UNITED STATES PATENT AND TRADEMARK OFFICE

Office Action Summary	Application No. 10/561,725	Applicant(s) PEIN, ANDREAS	
	Examiner JONATHAN W. MILES	Art Unit 3731

DETAILED ACTION

**Image 1 from Gernlein Fig. 2**

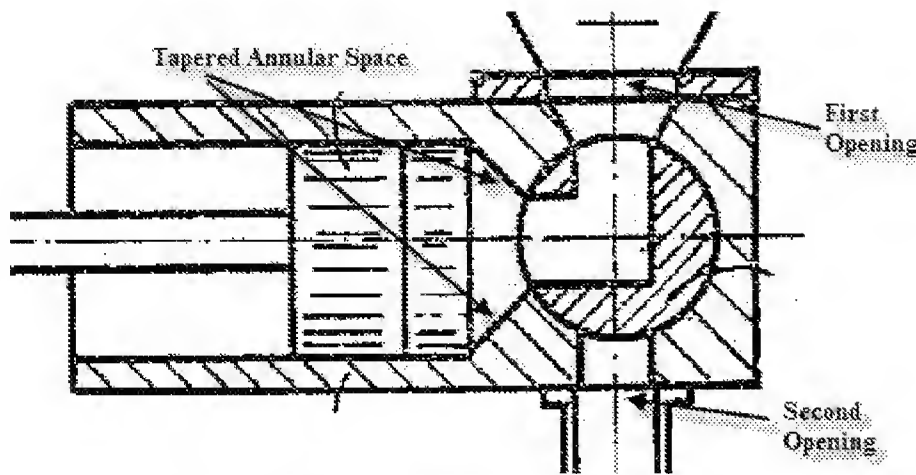
However, Gernlein discloses a fluid pump wherein the lowermost portion of the annular space tapers inwardly in a downward direction toward the suction-pressure space, the taper being formed by a frustoconical portion of the cylinder wall (see Image 1 above).

However Gernlein discloses a first and second openings being radially oriented and diametrically opposed with respect to the cylinder whereby the connecting device is installable in the first opening by initial insertion thereof through the second opening (see Image 1 above)..
